**APPENDIX E.11: COMMENTS AND RESPONSES TRAIL  
FOR COMMENTS RECEIVED DURING THE 30-DAY  
REVIEW OF THE DRAFT SCOPING REPORT**

SCOPING REPORT: Scoping and Environmental Impact Assessment (EIA) Process for the Proposed Development of a Solar Photovoltaic (PV) Facility (Kudu Solar Facility 1) and associated infrastructure, near De Aar, Northern Cape Province

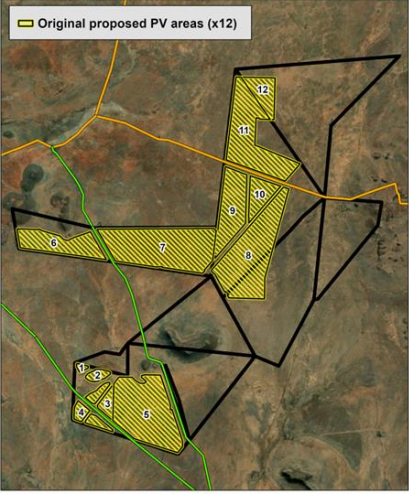
COMMENTS RECEIVED FROM THE DEPARTMENT OF FORESTRY, FISHERIES AND THE ENVIRONMENT (DFFE)			
NO.	DATE OF COMMENT, FORMAT OF COMMENT, NAME OF ORGANISATION/ I&AP	COMMENT	RESPONSE FROM THE ENVIRONMENTAL ASSESSMENT PRACTITIONER (EAP) / APPLICANT / SPECIALIST
		<p>indicates that the specialist study was commissioned within 50 days after the date of gazetting of the notice i.e., 20 March 2020 and was commissioned prior to 30 October 2020 respectively. Failure to comply with the abovementioned notices presents a risk to this application.</p> <ul style="list-style-type: none"> <li>○ Please note further that the protocols require certain specialists' to be registered with SACNASP. Refer to the relevant protocols in this regard.</li> <li>○ Please include a table in the final SR summarising the specialist studies required by the Screening Tool, a column indicating whether these studies will be conducted or not, and a column with motivation for any studies that will not be undertaken. Please note that if any of the specialists' studies and requirements recommended in the Department's Screening Tool are not commissioned, motivation for such must be provided in the report, as per the requirements of the Protocols.</li> <li>○ Please also ensure that the final SR includes the Site Verification Report as required by the relevant environmental themes and assessments.</li> <li>○ Should it be determined that there is a need for additional specialist studies to be undertaken based on the outcome of public participation, these must be commissioned and be included in the draft EIA reports for public comment.</li> </ul>	<p>Economic; Traffic; Geohydrology; and Geotechnical Assessments will comply with Appendix 6 of the 2014 NEMA EIA Regulations (as amended), and where relevant, Part A of GN 320 which contains site sensitivity verification requirements where a Specialist Assessment is required but no specific assessment protocol has been prescribed. However, in some instances there are no themes on the Screening Tool that relate to some of these studies and as such sensitivities cannot be verified against the Screening Tool. The Terrestrial Biodiversity and Species, and Avifauna specialist assessments will comply with the Assessment Protocols published in GN R1150 on 30 October 2020. The Battery Energy Storage System (BESS) High Level Safety, Health and Environment Risk Assessment will serve as a technical report, and the aforementioned legislation will thus not be applicable. The specialist studies to be conducted during the EIA Phase will therefore comply with the relevant legislation and will accordingly provide a detailed description of the methodology, project infrastructure and locations, structures assessed, limitations, proposed rehabilitation, and recommendations for authorisation.</p> <ul style="list-style-type: none"> <li>▪ The Scoping Level Specialist Assessments and Inputs (Appendix G of the FSR) are high level and intended for the Scoping Phase, and include Site Sensitivity Verifications, where relevant and required, as per the requirements of the Assessment Protocols published in March 2020 (GN 320) and October 2020 (GN 1150). Furthermore, the Scoping Level Specialist Assessments and Inputs include a detailed description of the limitations of their Scoping Level Inputs report, as well as feedback on the season that the field work and Site Sensitivity Verifications were undertaken. The relevant specialists have complied with the protocols in terms of the undertaking of the field surveys in the correct season. Details on the suitability of the season for fieldwork will be provided in the Specialist Assessments during the EIA Phase.</li> </ul>

<b>COMMENTS RECEIVED FROM THE DEPARTMENT OF FORESTRY, FISHERIES AND THE ENVIRONMENT (DFFE)</b>			
<b>NO.</b>	<b>DATE OF COMMENT, FORMAT OF COMMENT, NAME OF ORGANISATION/ I&amp;AP</b>	<b>COMMENT</b>	<b>RESPONSE FROM THE ENVIRONMENTAL ASSESSMENT PRACTITIONER (EAP) / APPLICANT / SPECIALIST</b>
			<ul style="list-style-type: none"> <li>▪ The Environmental Assessment Practitioner (EAP) will clearly indicate the most reasonable recommendation substantiated by defensible reasons should any of the appointed Specialists specify contradicting recommendations in their assessments during the EIA Phase. Further expert advice will be sought to substantiate such recommendations, if and where required.</li> <li>▪ As noted above, the relevant Specialist Assessments for the EIA Phase are being conducted in adherence with the Assessment Protocols of March 2020 (GN 320) and October 2020 (GN 1150). This is also noted in the Plan of Study for the EIA (Chapter 7 of the FSR). None of the specialists were appointed prior to the commencement of the abovementioned Assessment Protocols.</li> <li>▪ The Specialist Declaration of Interest Forms that were originally included in the DSR and retained in this FSR (relevant appendices of the Scoping Level Assessments in Appendix G) indicate the scientific organisation registration/member number and status of registration/membership for each specialist. Cognizance has been taken of the specific professional registration (SACNASP) requirements of specialists undertaking work in terms of the Assessment Protocols, and this has been complied with. Registration has also been verified on the SACNASP database website.</li> <li>▪ Section 4.3 of Chapter 4 of the DSR did include a table listing the specialist studies required by the Screening Tool, whether the study would be undertaken in the Scoping and EIA Process, the type of assessment to be undertaken in the Scoping and EIA Process, as well as feedback or motivation as to why a certain study would not be commissioned, and a reference to where the study can be found in the DSR. This has been retained in the FSR. As indicated in</li> </ul>

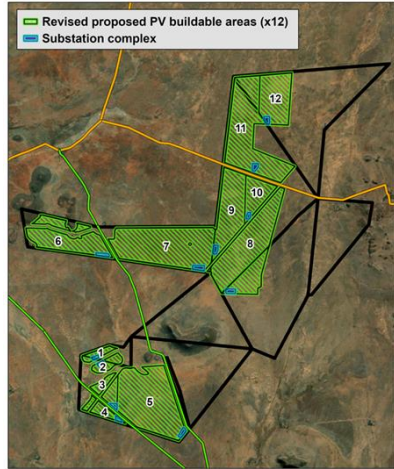
<p><b>Layout &amp; Sensitivity Maps</b></p> <ul style="list-style-type: none"> <li>▪ The inconsistency of the area/footprint for the proposed development on Figure 3-29: Avifaunal sensitivity zones, Figure A. Locality map of the proposed Kudu Projects (attached as Appendix C) and Figure 7.3:</li> </ul>	<p><b>CSIR:</b> As noted in the DSR and FSR, the <u>preferred site</u> for the proposed Kudu Solar Facility 1 to 12 comprises the full extent of the affected farm portions which cover a combined footprint of 8 150 ha, which serves as the <u>study area</u> for this Scoping and EIA Process. Therefore, the terms</p>

COMMENTS RECEIVED FROM THE DEPARTMENT OF FORESTRY, FISHERIES AND THE ENVIRONMENT (DFFE)			
NO.	DATE OF COMMENT, FORMAT OF COMMENT, NAME OF ORGANISATION/ I&AP	COMMENT	RESPONSE FROM THE ENVIRONMENTAL ASSESSMENT PRACTITIONER (EAP) / APPLICANT / SPECIALIST
		<p>Revised Scoping Buildable Area for the PV Facility, On-Site Substation Complex, and Environmental Sensitivities for the proposed project has been noted. Therefore, you are advised to provide a map showing similar development area/footprint for only Kudu 1 solar facility in the final report and be in line with the size of the site to be developed. Please ensure each specialist indicate the area assessed for the proposed Kudu 1 solar facility, i.e., make reference into the specialist studies report (the layout plan) where it indicates the area assessed.</p>	<p>“site” and “study area” are used synonymously in the report. This is depicted in Figure 1 below.</p>  <p><b>Assessment study area / preferred site</b> = Total extent of the land portions identified for the development. This entire extent was assessed by the specialists.</p> <p><b>Figure 1: Study Area / Preferred Site</b></p> <p>At the commencement of this Scoping and EIA Process, the Original Scoping Buildable Areas, which fall within the study area / preferred site, were identified by the Project Applicant following the completion of high-level environmental screening based on the Screening Tool. The <u>Scoping Buildable Areas</u> serve as the “<u>development footprints</u>” for the 12 x PV</p>

COMMENTS RECEIVED FROM THE DEPARTMENT OF FORESTRY, FISHERIES AND THE ENVIRONMENT (DFFE)			
NO.	DATE OF COMMENT, FORMAT OF COMMENT, NAME OF ORGANISATION/ I&AP	COMMENT	RESPONSE FROM THE ENVIRONMENTAL ASSESSMENT PRACTITIONER (EAP) / APPLICANT / SPECIALIST
			<p>proposed PV facilities and fall within the preferred site / study area. This is depicted in Figure 2 below.</p>  <p><b>Original proposed PV areas / development footprint</b> = Preliminary PV areas (buildable areas) identified and proposed by the project proponent.</p> <p><b>Figure 2: Original Scoping Buildable Areas / development footprint</b></p> <p>Following the identification of sensitivities by the specialists and relevant specialist fieldwork during the Scoping Phase, the Project Developer took such sensitivities, and other considerations, into account and formulated the Revised Scoping Buildable Areas or development footprints for the proposed 12 x PV areas. These are indicated in Figure 3.</p>

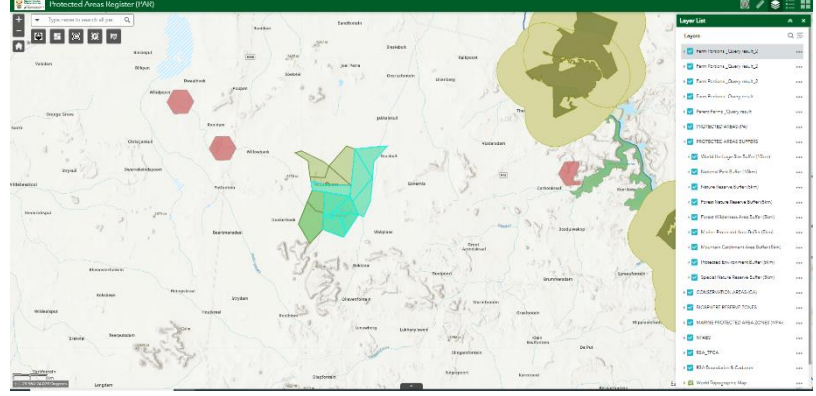
COMMENTS RECEIVED FROM THE DEPARTMENT OF FORESTRY, FISHERIES AND THE ENVIRONMENT (DFFE)			
NO.	DATE OF COMMENT, FORMAT OF COMMENT, NAME OF ORGANISATION/ I&AP	COMMENT	RESPONSE FROM THE ENVIRONMENTAL ASSESSMENT PRACTITIONER (EAP) / APPLICANT / SPECIALIST
	Mashienyane Portia Makitla)	<p>The Directorate: Biodiversity Conservation has reviewed and evaluated the reports and does not have any objection to the Scoping Report and the Plan of Study, however, must comply with the procedures for the assessment and minimum criteria for reporting on identified environmental themes in terms of sections 24(5)(A) and (H) and 44 of the National Environmental Management Act, 1998.</p> <p>The final report must comply with all the requirements as outlined in the Environmental Impact Assessment (EIA) guideline for renewable energy projects and the Best Practice Guideline for Birds &amp; Solar Energy for assessing and monitoring the impact of solar energy facilities on birds in Southern Africa.</p> <p>In conclusion, the Public Participation Process documents related to Biodiversity EIA for review and queries should be submitted to the Directorate: Biodiversity Conservation at Email; BCAdmin@dffe.gov.za for the attention of Mr. Seoka Lekota.</p>	<p>Terrestrial Biodiversity, and Aquatic Biodiversity will comply with GN 320. The Visual; Heritage (Archaeology and Cultural Heritage); Palaeontology; Socio-Economic; Traffic; Geohydrology; and Geotechnical Assessments will comply with Appendix 6 of the 2014 NEMA EIA Regulations (as amended), and where relevant, Part A of GN 320 which contains site sensitivity verification requirements where a Specialist Assessment is required but no specific assessment protocol has been prescribed. However, in some instances there are no themes on the Screening Tool that relate to some of these studies and as such sensitivities cannot be verified against the Screening Tool. The Terrestrial Biodiversity and Species, and Avifauna specialist assessments will comply with the Assessment Protocols published in GN R1150 on 30 October 2020. The Battery Energy Storage System (BESS) High Level Safety, Health and Environment Risk Assessment will serve as a technical report, and the aforementioned legislation will thus not be applicable.</p> <p>The Avifauna Scoping Level Assessment (Appendix G.4 of the FSR) has taken into consideration the BirdLife South Africa (BLSA) Guidelines for assessing and monitoring the impact of solar power generating facilities on birds in southern Africa (Jenkins, A.R., Ralston-Patton, Smit-Robinson, A.H. 2017). This will also be carried through into the EIA Phase.</p> <p>The DFFE Environmental Impact Assessment (EIA) guideline for renewable energy projects will be taken into consideration in the EIA Phase and captured in the Draft EIA Report, where applicable.</p> <p>The DFFE Directorate: Biodiversity Conservation (BCAdmin@dffe.gov.za) was included on the I&amp;AP database at the outset of the Scoping and EIA Phase and will be retained on the database and provided with reports as they become available for comment during the</p>
